APPLICATION FOR CERTIFICATE OF APPROPRIATENESS

Address 3629 East Broad Street

Applicant's Report for Final Review of New Construction

3629 & 3631 (Proposed) East Broad Street - CAR Conceptual Review Notes

CONTEXT ELEVATIONS

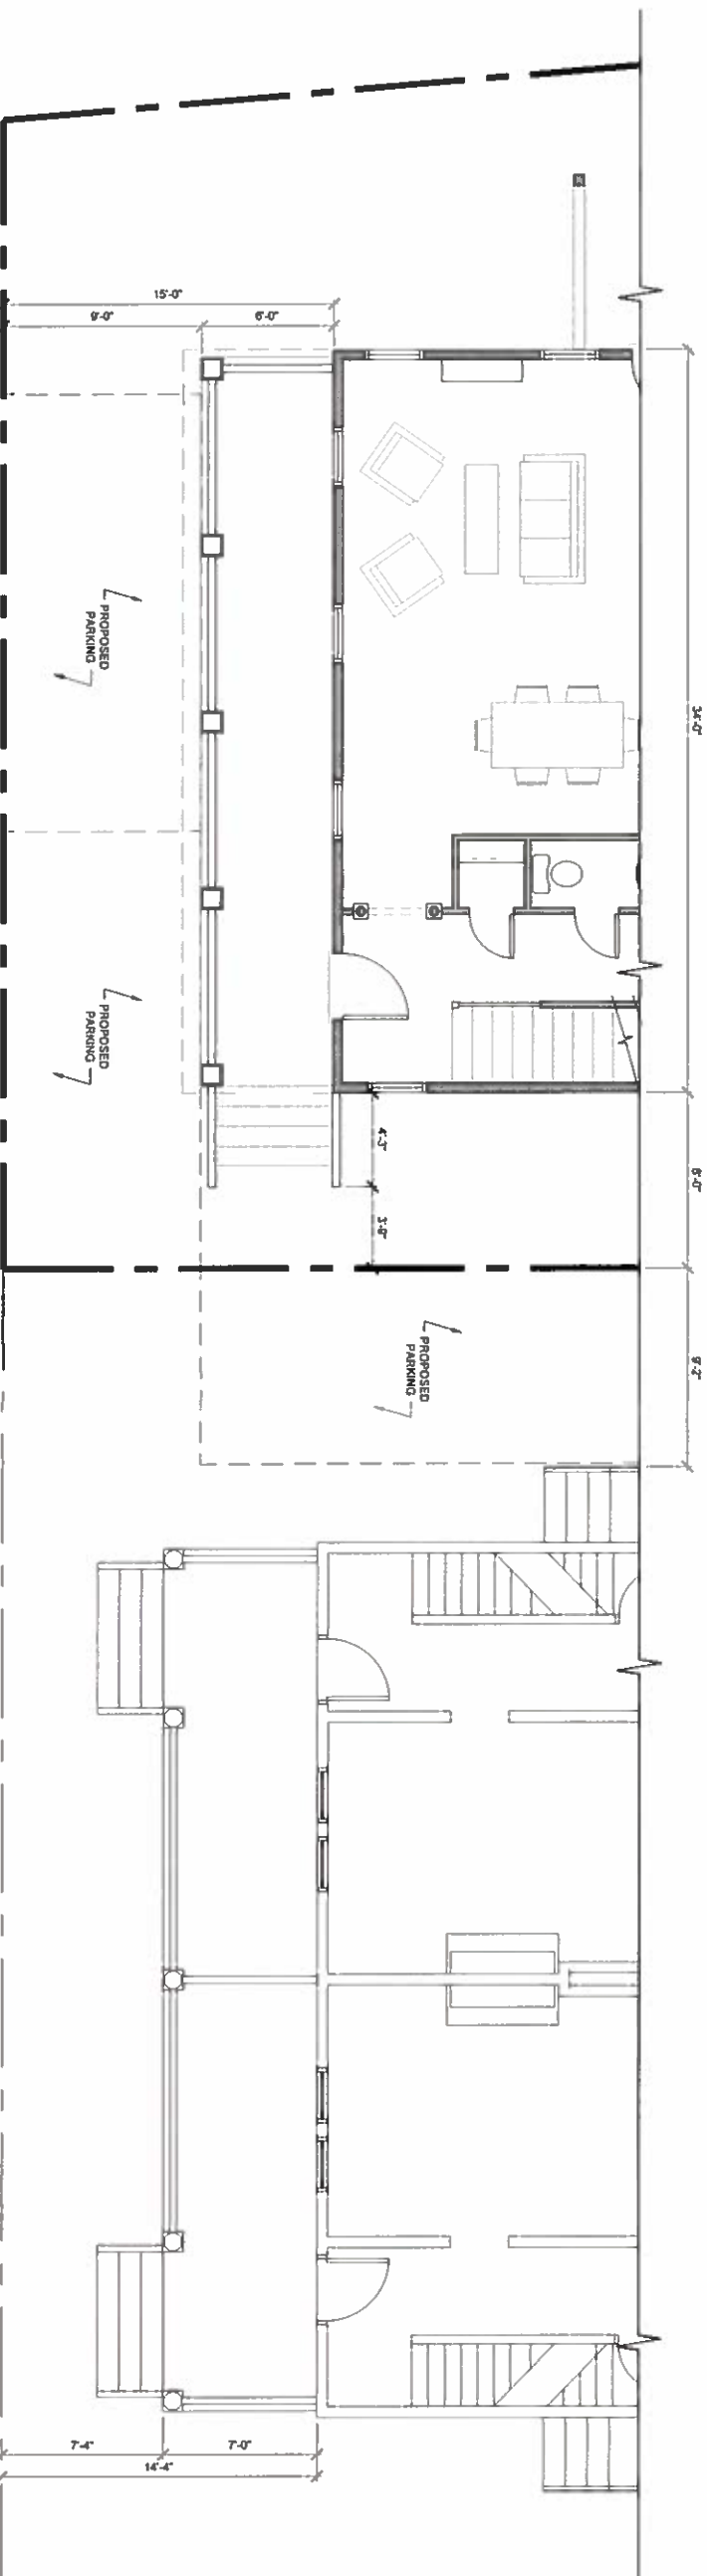
- 5- *The Guidelines* – Siting, pg 46. As shown on Page C-1 of the enclosed drawings, both the context setbacks and the context elevations mimic the adjoining properties.

WEST FACADE
SCALE: 1/4"=1'-0"

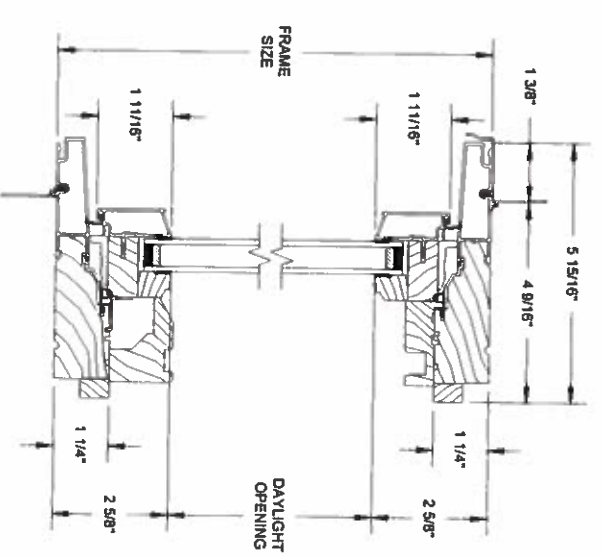
- Staff recommends the fenestration be modified on the highly visible west elevation to include consistent window sizes and lite configurations.

- 4- Per CAR Staff Recommendations, consistent window sizes were to be placed on the west elevation. During the Conceptual Review, the Applicant explained that the 1st story window is to be a fixed, casement window and the 2nd story window is a double hung at the stair landing. As shown on the enclosed Plans, the stair landing window is consistent with its lite configuration and size when compared to other double hung windows on the home.
